2023 Diving Code

Object of Amendment

Rules for the Diving Systems
Guidance for Diving Systems

ID: DD23-13

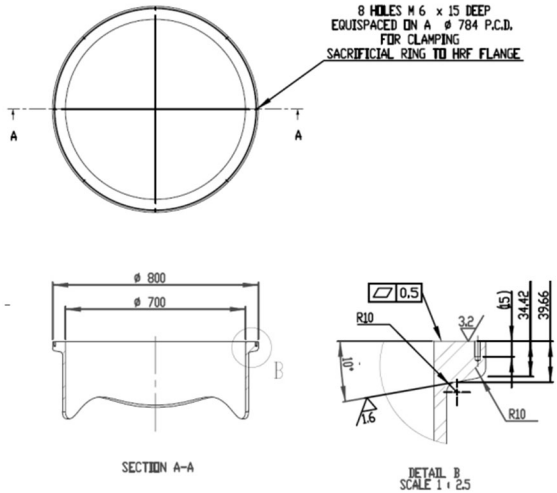
Amended	Original	Remarks
<p><u>opening during normal operations and if any locking mechanism is provided, it is to be able to be operated from both sides.</u></p> <p>(5) <u>Arrangements are to be provided to enable a helpless diver to be taken into the HBSC PVHO.</u></p> <p>(6) <u>The seating or other arrangements provided are to be designed for the maximum number of occupants and provide an adequate degree of protection to the divers from impact collisions during launch and while the HBSC is deployed.</u></p> <p>(7) <u>The PVHO is to have a service lock through which provisions, medicine and equipment may be passed into the PVHO while its occupants remain under pressure. Locks are to be designed to prevent accidental opening under pressure and, where necessary, interlocks are to be provided for this purpose. The dimensions of the service lock are to be adequate to enable essential supplies to be transferred into the PVHO.</u></p> <p>(8) <u>The HBSC is to be provided to allow the occupants to be observed and as far as practicable allow an occupant to observe divers outside the bell. Viewports are to be protected and situated so that the risk of damage is minimized.</u></p> <p>(9) <u>Where it is intended to carry out decompression of the divers after hyperbaric evacuation in another surface compression chamber, then consideration is to be given to the suitability of the mating arrangements on that surface compression chamber. Where necessary, a suitable adapter and clamping arrangements are to be provided on the HBSC conforming to Fig. 5.1 and on the other surface compression chamber (e.g., a hyperbaric reception facility) conforming to Fig. 5.2.</u></p>

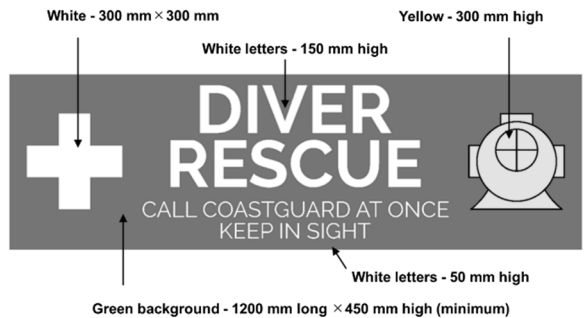
Amended	Original	Remarks
<p><u>(b) Each HBSC is to be marked with at least three identical signs, Fig. 5.3. One of these markings is to be on top of the unit and be clearly visible from the air and the other two be mounted vertically on both sides and as high as possible and be capable of being seen while the unit is afloat.</u></p> <p><u>(c) The following (i) to (vi) instructions and equipment are to be clearly visible and be kept readily available while the HBSC is afloat:</u></p> <p><u>i) towing arrangements and buoyant towline;</u></p> <p><u>ii) all external connections, for essential services;</u></p> <p><u>iii) maximum gross weight of the HBSC in air;</u></p> <p><u>iv) lifting point and load rating;</u></p> <p><u>v) name of the diving unit and port of registration; and</u></p> <p><u>vi) emergency contact details.</u></p> <p><u>(d) Where appropriate, the following (i) to (v) warning instructions are to be permanently displayed on every HBSC in two separate locations so as to be clearly visible while the craft is afloat:</u></p> <p><u>“Unless specialized diving assistance is available:</u></p> <p><u>i) do not touch any valves or other controls;</u></p> <p><u>ii) do not try to get occupants out;</u></p> <p><u>iii) do not connect any gas, air, water or other services;</u></p> <p><u>iv) do not attempt to give food, drinks or medical supplies to the occupants; and</u></p> <p><u>v) do not open any hatches.”</u></p> <p><u>(12) HBSC is to comply with the “Totally enclosed lifeboats” as defined in Chapter 4.6 of the LSA Code</u></p>
